California High-Speed Train Project

Agreement No.: HSR 13-06
Book 3, Part D, Subpart 5

Design Variance Report

DESIGN VARIANCE COVER SHEET

CONTRACT NO.
DRAWING NO.
TT-D1010
SCALE
AS SHOWN
SHEET NO.

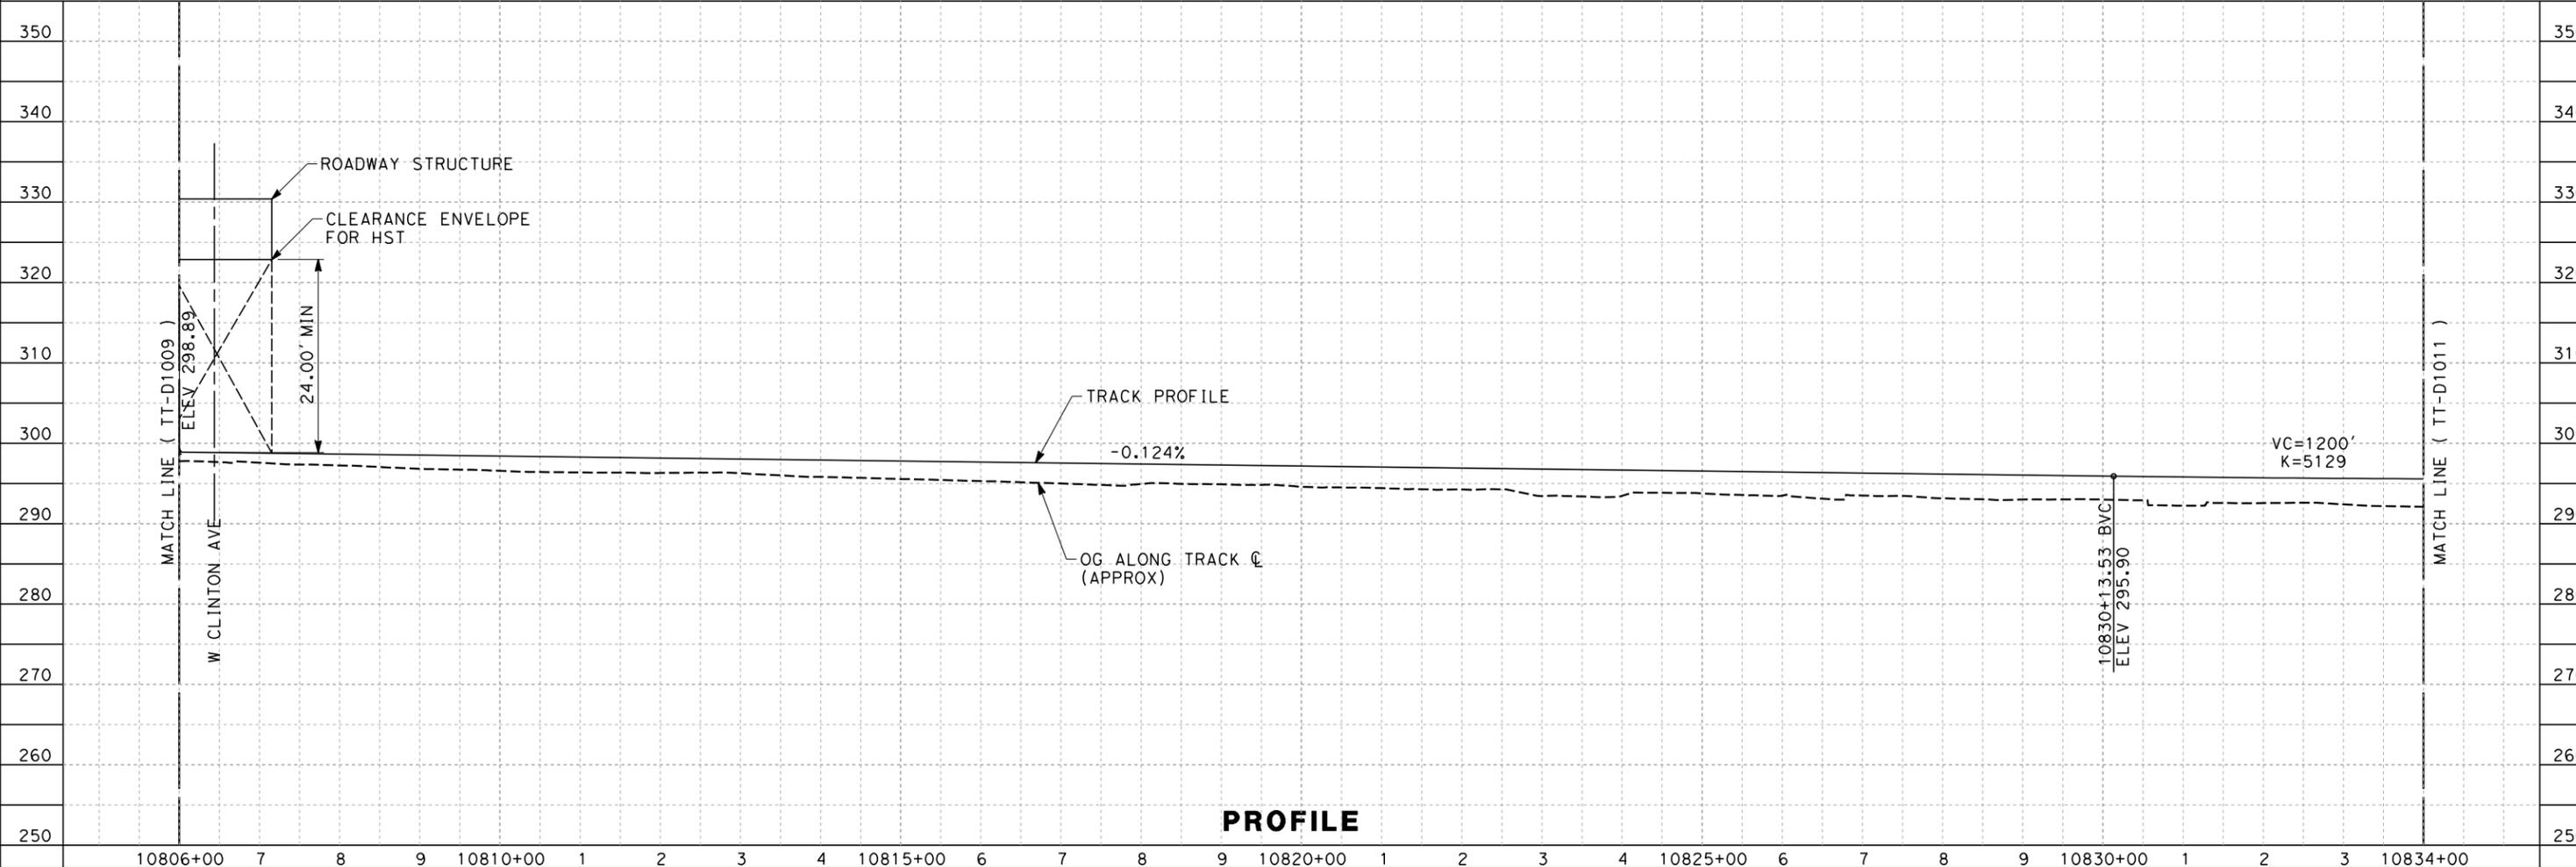
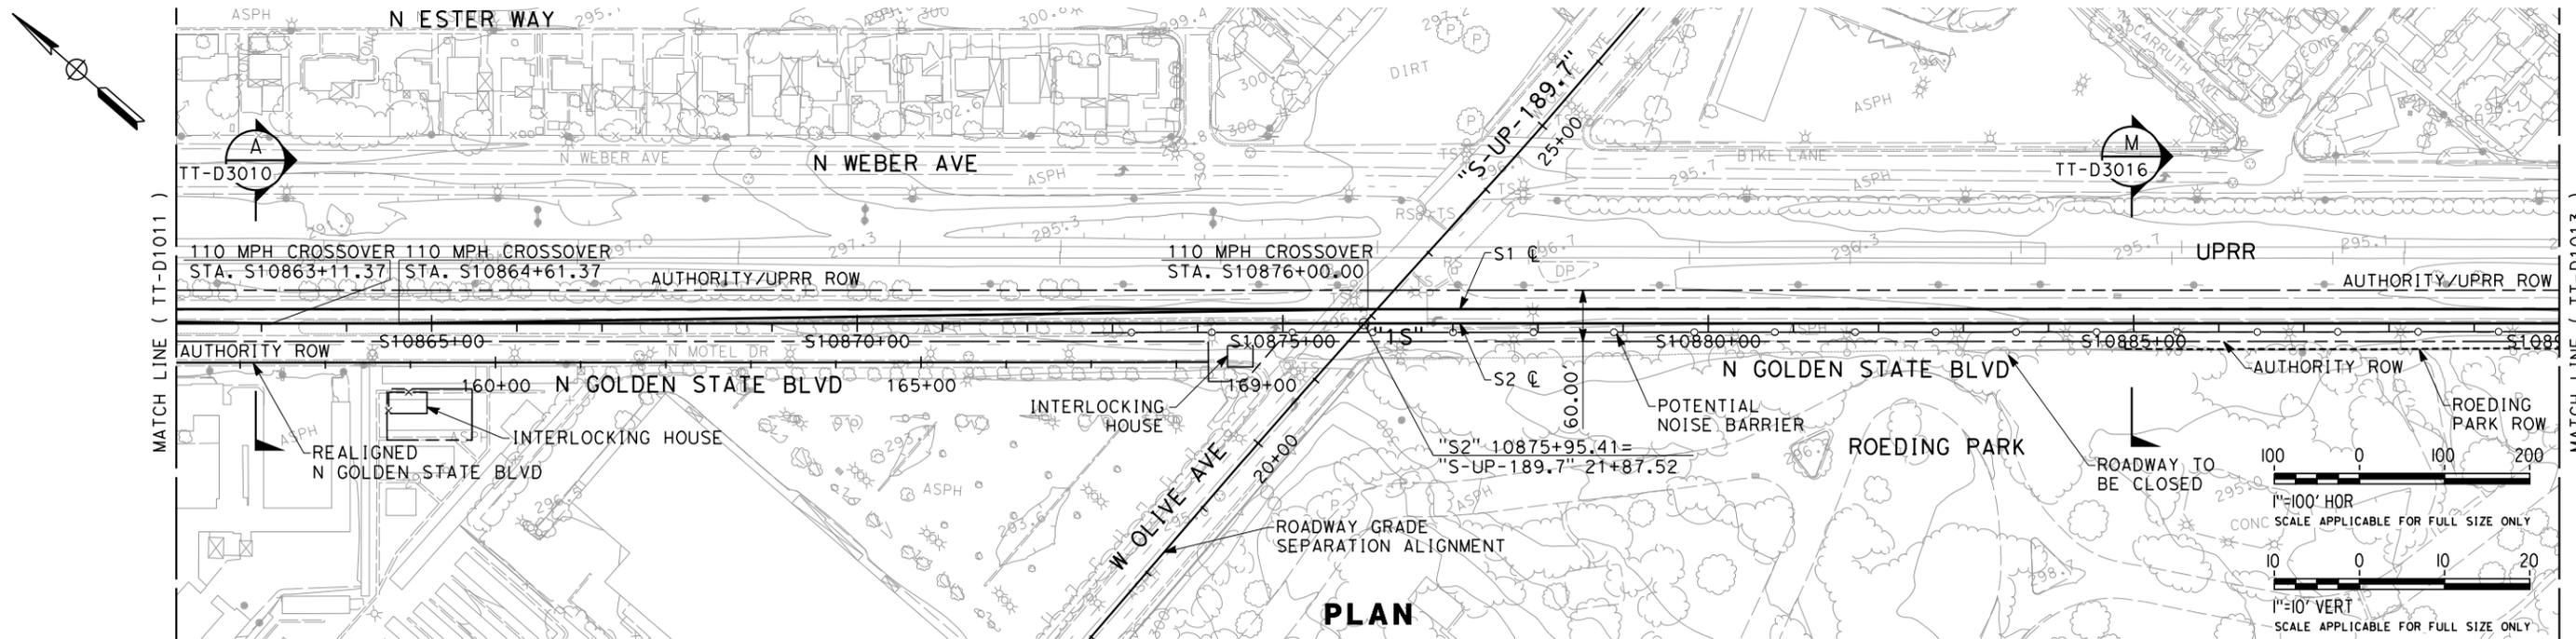
<p>CHSTP DESIGN REQUIREMENT Include reference to drawings, design criteria, technical memos, specifications</p>	<p>TM2.1.3 – Turnouts and Station Tracks Rev 0, 06/29/09 Figure 6.1.4 stipulates the desirable run time to determine the “minimum distance between the end of station turnout and crossover turnout, where they are on the same track,” should be 1.5 seconds, or a minimum of 1 second.</p> <p>Verbal advice from EMT stated that station crossovers should not be more than a mile from the station.</p>
<p>DESIGN CRITERIA REQUIRING A VARIANCE</p>	<p>Desirable run time to determine the “minimum distance between the end of station turnout and crossover turnout, where they are on the same track,” should be 1.5 seconds, or a minimum of 1 second.</p>
<p>REASON FOR REQUESTING A VARIANCE</p>	<p>Crossovers for Fresno stations at STA 10851+72.74 to 10863+11.37 and 108664+61.37 to 10876+00.00. Station platform ends are at 10970+00. This is a maximum separation of 14,127ft.</p>

Ashlan Avenue - Exhibit 5

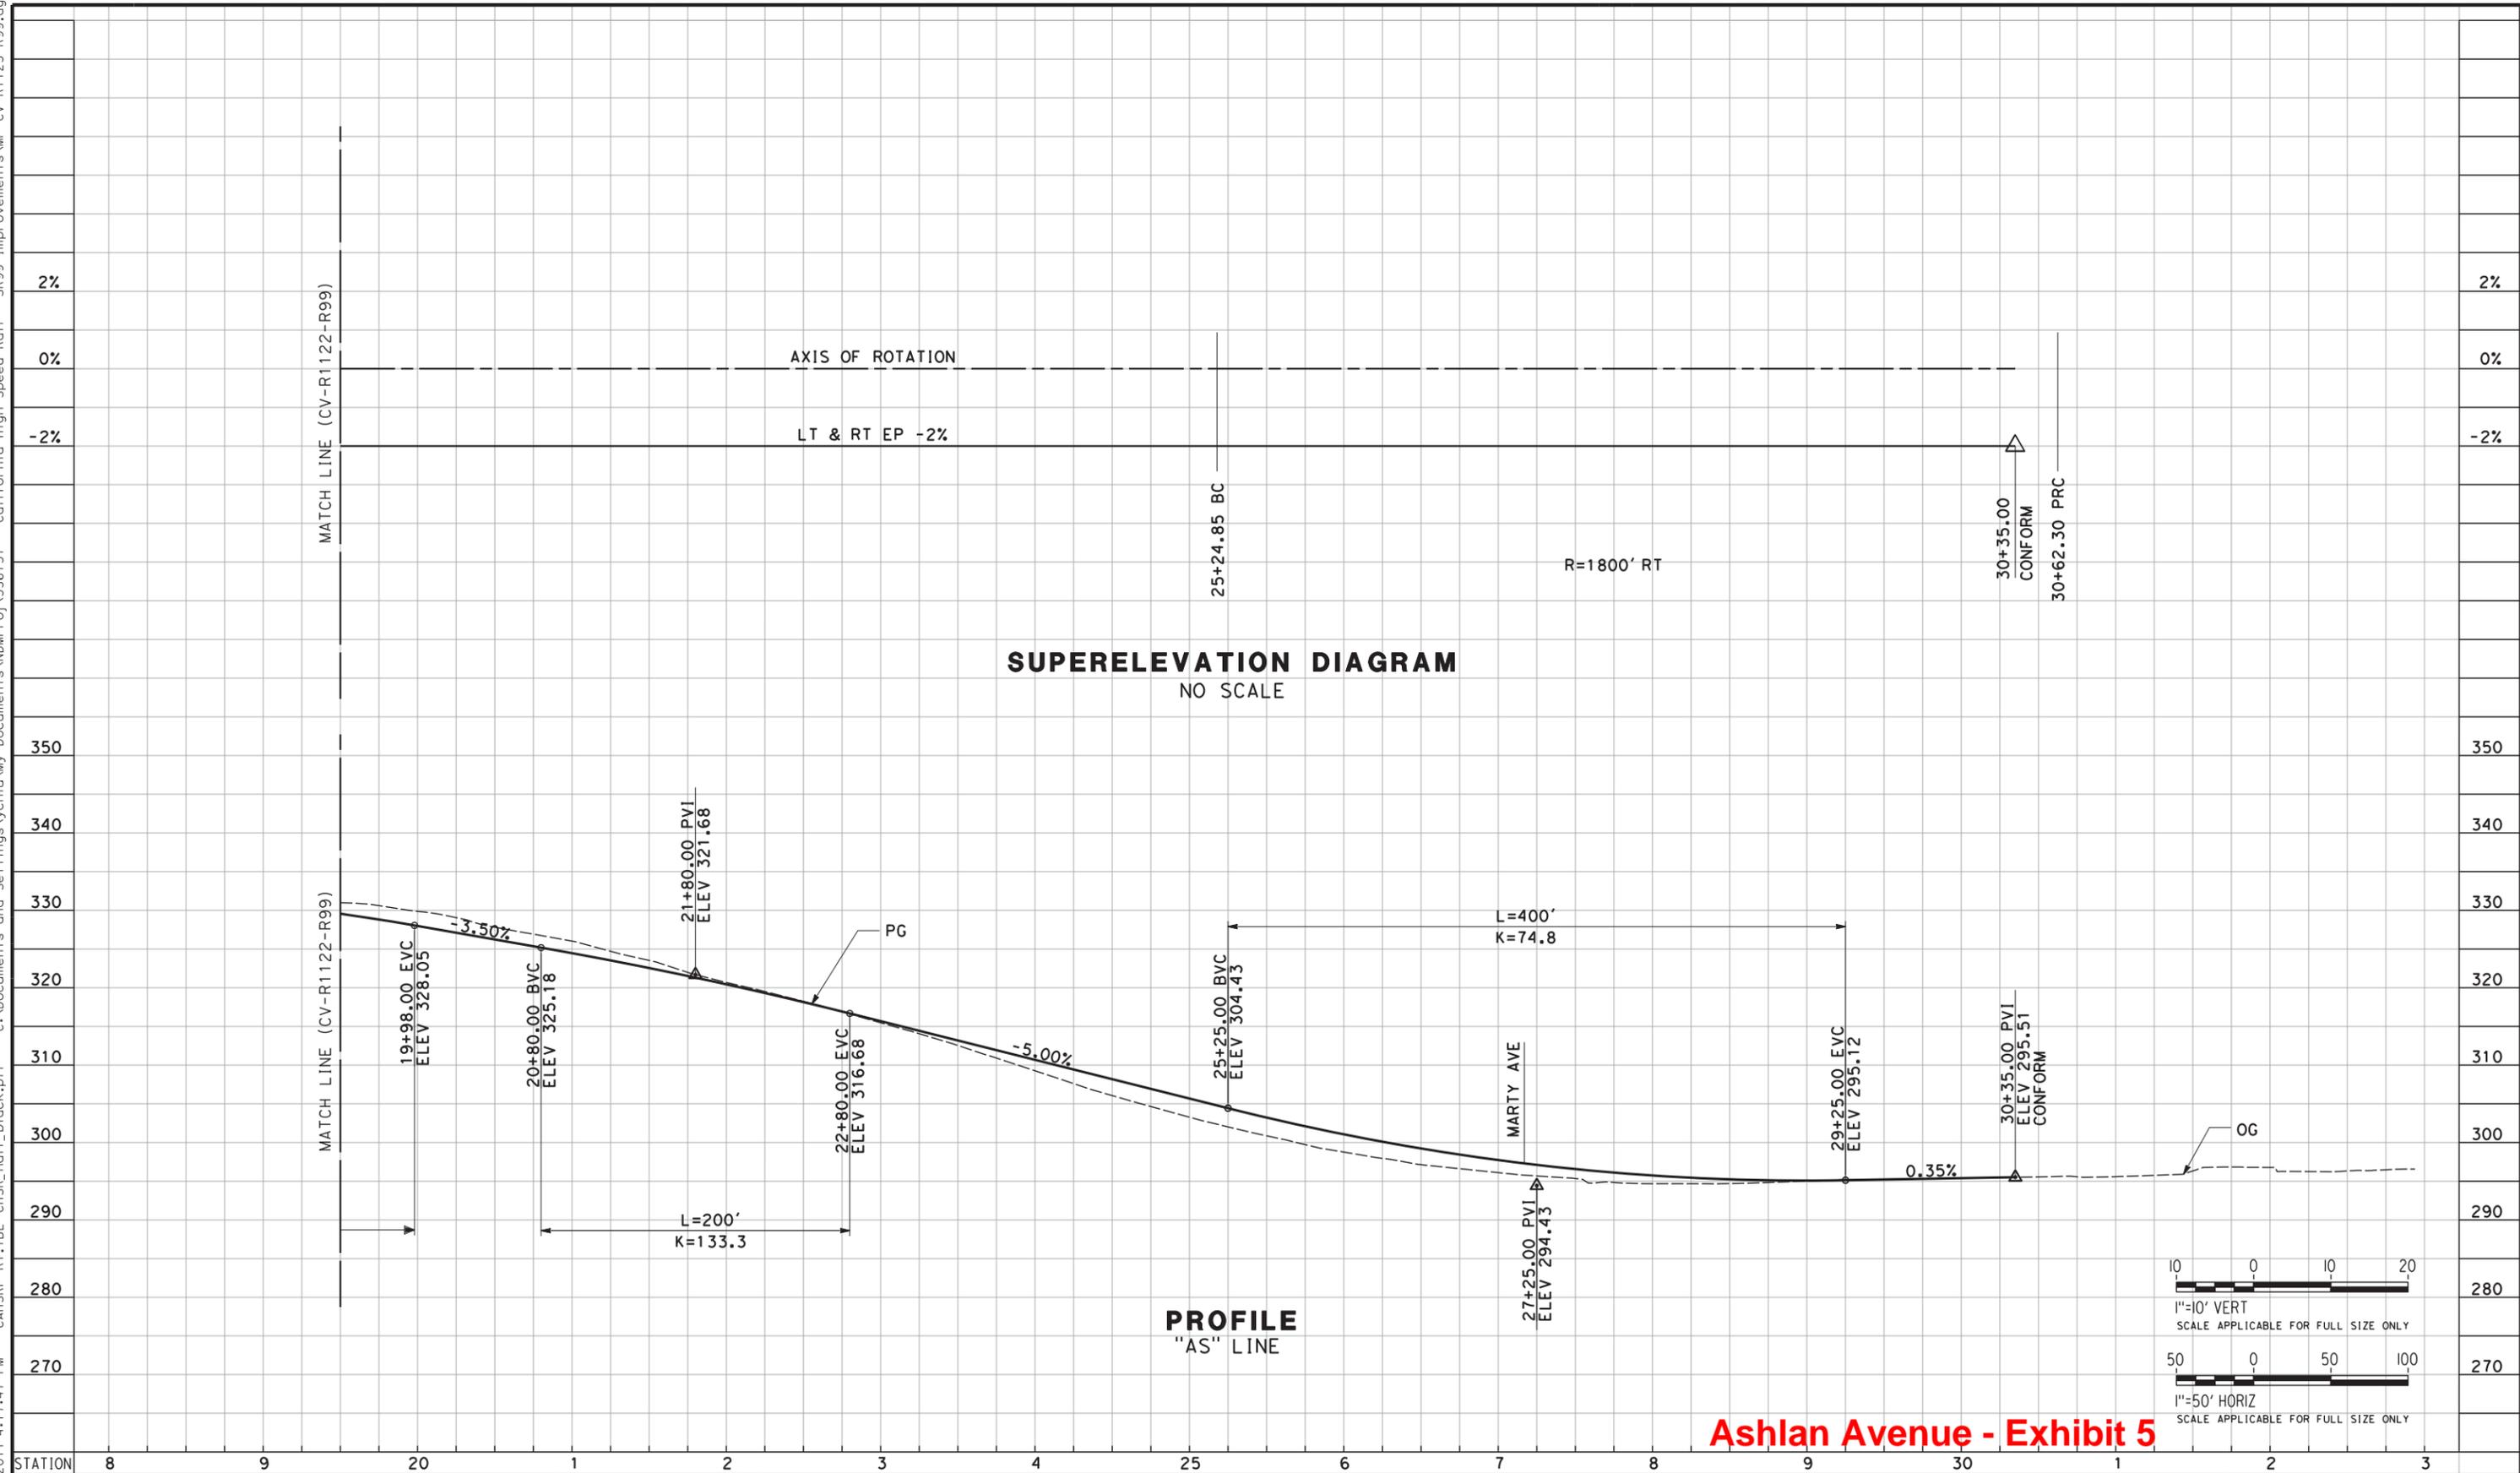
Raising Ashlan Ave profile to provide the 27 feet clearance over HSR will result in impacts to the approach and ramp features of Ashlan Ave and SR99 interchange, making the revisions impractical. Exhibits 1 through 5 show draft 30% design plans at Ashlan Ave. Exhibit 4 shows revised Ashlan profile grade of 6.6% to the Caltrans Ashlan/SR99 interchange ramps. This grade is already substandard, pending consideration and approval by Caltrans. Since Ashlan/SR99 interchange in its existing conditions does not meet current standards, further revisions of its configurations may lead to the requirement of replacing the interchange.
